SUBDIVISION REPORT - CONCEPT/DEVELOPMENT PLAN

► **FILE #:** 11-SA-22-C

► **SUBDIVISION:** FAIRVIEW ROAD SUBDIVISION

**** See the Requested Variances and Alternative Design Standards
memo attached to the staff report**

SHEET C-1

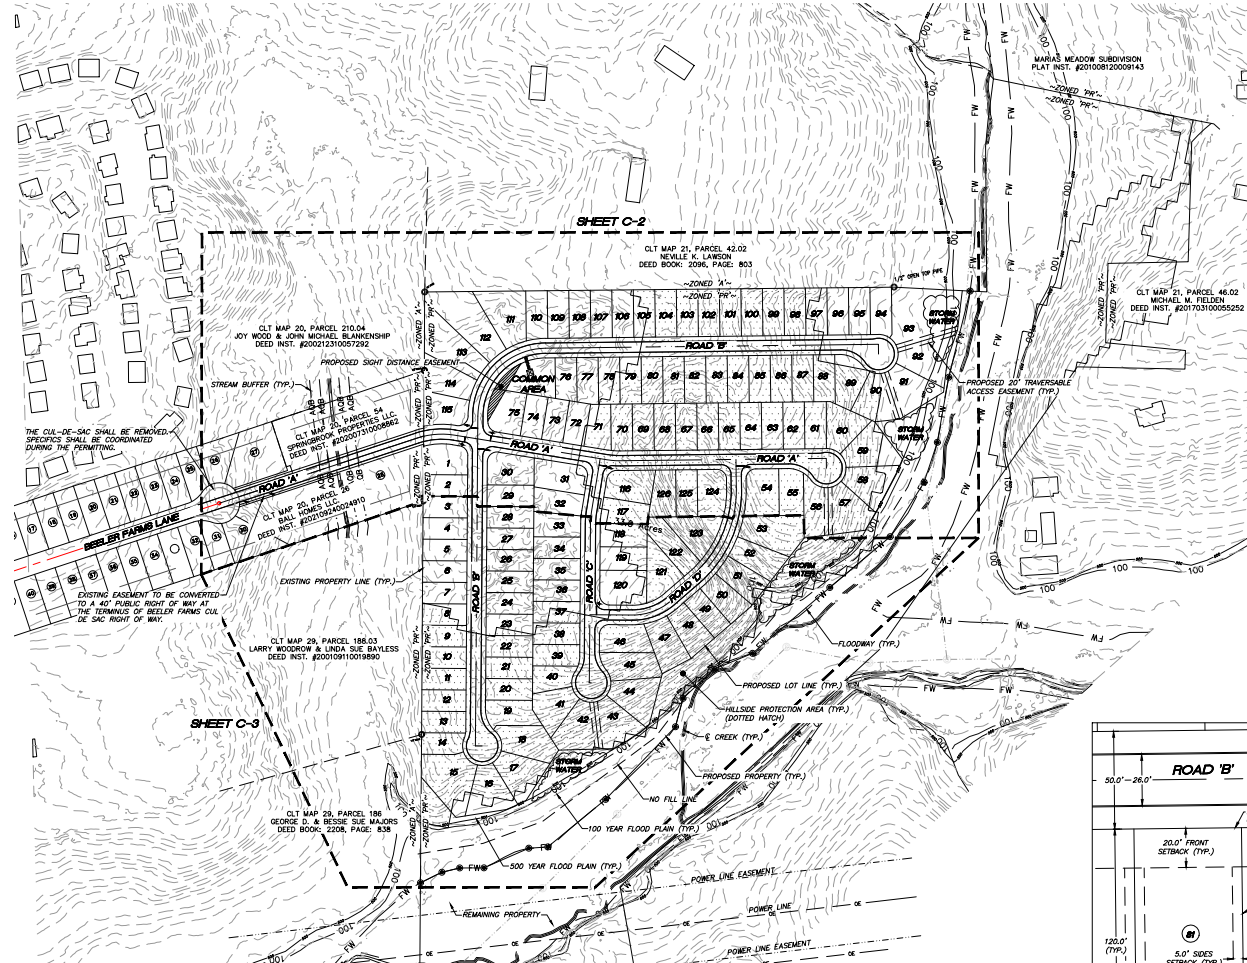
c) The applicant is requesting a reduction of the required 50-ft right-of-way to 40-ft for the portion of Road 'A' in Beeler Farms. This will result in a 5-ft strip of land between the two lots at the end of the existing cul-de-sac and the new public right-of-way. The strips of land will remain part of the common area lot and the house lot located on the east side of the stream. Even though the existing lots are near Road 'A', they will not have the benefit of using that frontage to access their rear yards. The purpose of the requested right-of-way reduction and the 5-ft strips of land is so the side lot lines of the two adjacent lots do not touch the new public right-of-way and become front lot lines, which would make the existing houses non-conforming to the front setback standards and restrict the placement of accessory structures. Knox County Engineering and Public Works (EPW) does not oppose the right-of-way reduction. EPW is recommending a reduction of the pavement width to 20-ft between the existing cul-de-sac and the intersection of Road 'A' and Road 'B'. This is to constrict the travel lanes as a traffic calming measure. This segment of roadway will be required to have a sidewalk.

If the subdivision is approved as requested, Knox County will require a sidewalk along the full length of Road 'A' (extension of Beeler Farms Lane) and a connection to the proposed greenway from the Road 'A' cul-de-sac.

If the Planning Commission approves the subdivision as requested, Knox County Engineering and Public Works recommends approval of the vertical curve and horizontal curve variances as requested. The reductions comply with AASHTO road standards for the design speed of 25 MPH. By default, residential streets in Knox County are posted with a speed limit of 25 MPH.

SHEET C-7

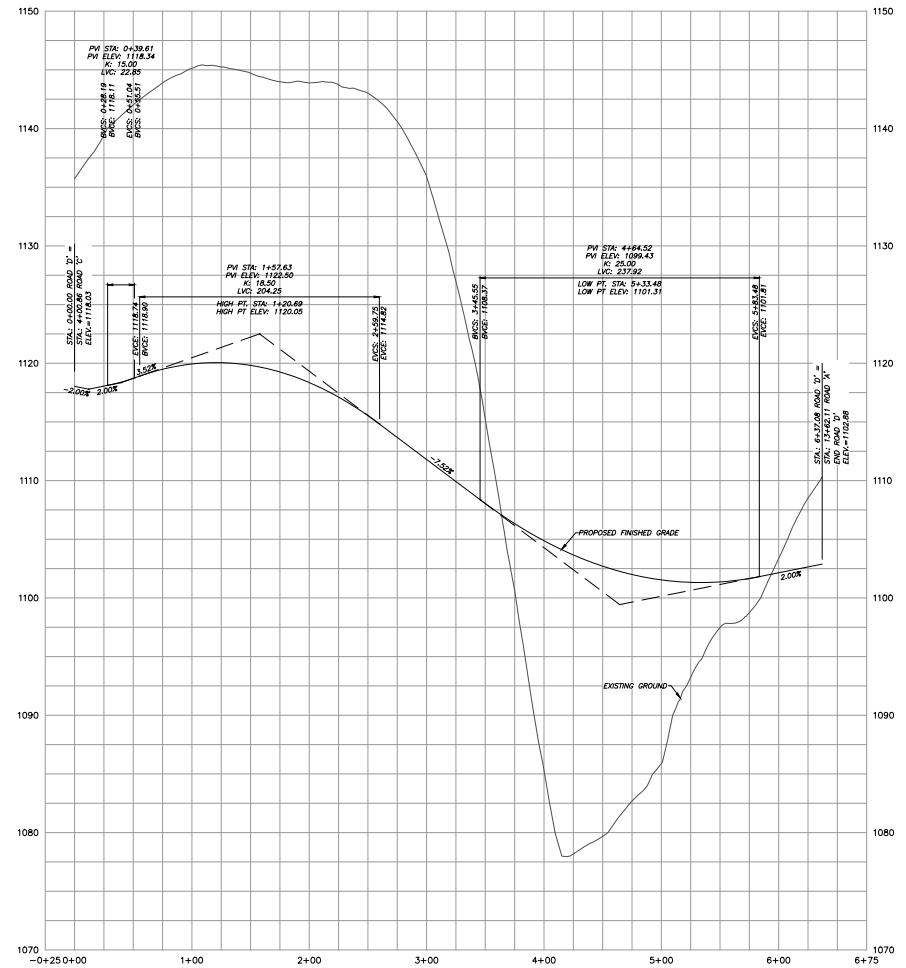
1. Reduce the minimum vertical curve tangent K value from K=25 to K=18.5 at STA 1+57.63, Road D
